STATE OF HAWAII
DEPARTMENT OF BUSINESS, ECONOMIC DEVELOPMENT, AND TOURISM
HAWAII HOUSING FINANCE AND DEVELOPMENT CORPORATION
677 QUEEN STREET, SUITE 300
HONOLULU, HAWAII 96813
PHONE: (808) 587-0620

Re: **Request for Approval of Exemptions Pursuant to Section 201H-38, Hawaii Revised Statutes, for the Proposed Mililani High School Teacher Workforce Housing Project**
95-1200 Meheula Parkway, Mililani, HI 96789
TMK Nos.: (1) 9-5-001: 017 and 054 (Portions)

PROPOSED EXEMPTIONS PURSUANT TO SECTION 201H-38, HRS

SHEET NO.
A0

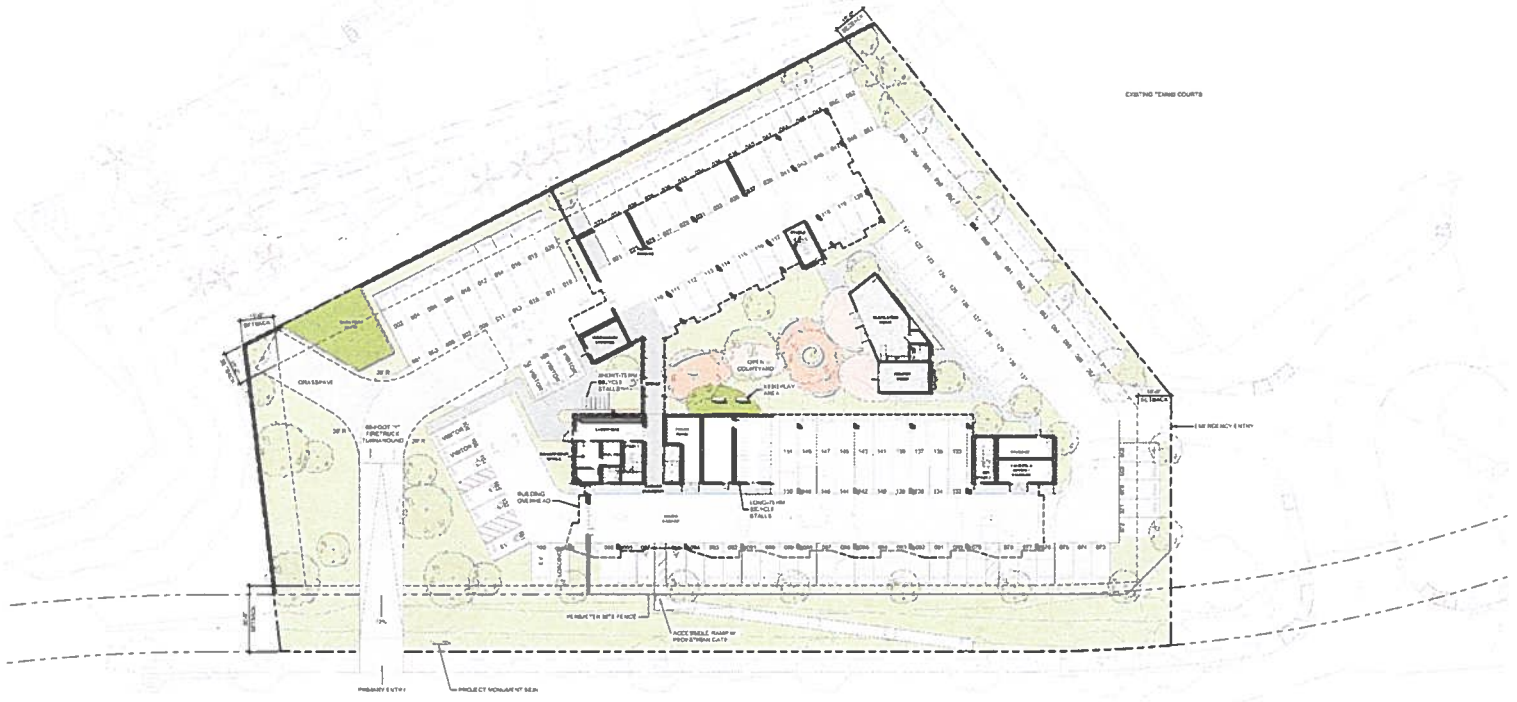
c. Label the TMKs on the site plan.
